## MEMORANDUM

Date: October 1, 2020  
From: Diab Jerius (djerius@winchester.us)  
To: Winchester Select Board  
Subject: Musings on the Waterfield Lot Proposals  
Cc: Lisa Wong, Brian Szekely  
File: LetterToSB-2020-09-27.lyx  
Version: 1.3

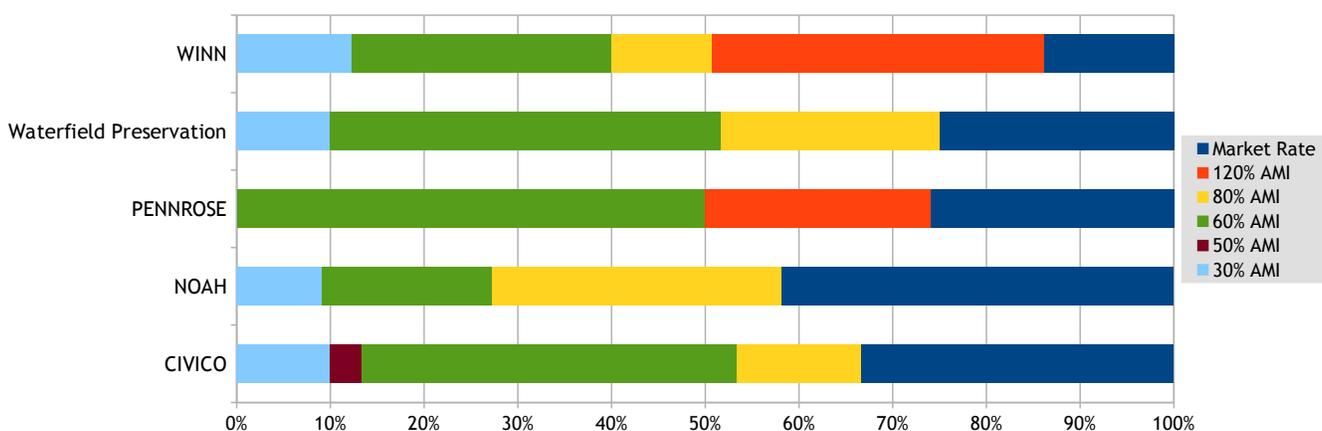
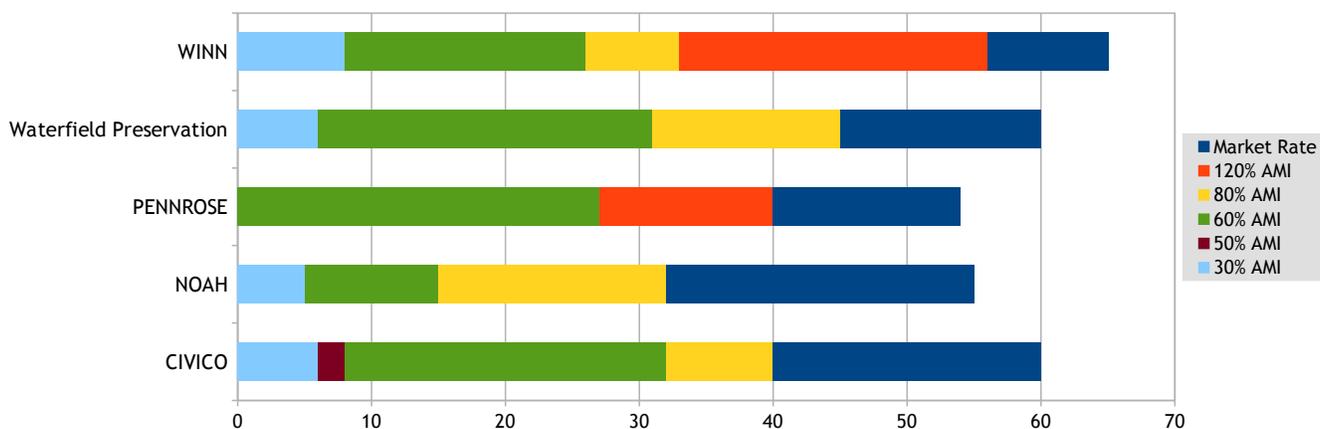
The following charts<sup>3</sup> provides a summary of the distribution of units for each proposal, structured so as to more easily compare the number of units below a given level of affordability. The first shows distribution of units as a percentage of the total. The second shows distribution as number of units.

While the RFP noted 120% AMI as the expected upper range for affordable units, only two of the developers, Winn and Pennrose, propose them. Surprisingly, NOAH, the local, non-profit developer, has the lowest percentage of affordable units.

While Civico is my preferred candidate overall, if one were to select *solely* on the number and distribution of units, Winn would prevail. If Civico were to replace five of its market rate units with workforce units it would better respond to the RFP as well as raise its overall affordable percentage from 66% (the second lowest, after NAOH) to 75%, which would bring it in line with Waterfield Preservation and Pennrose.
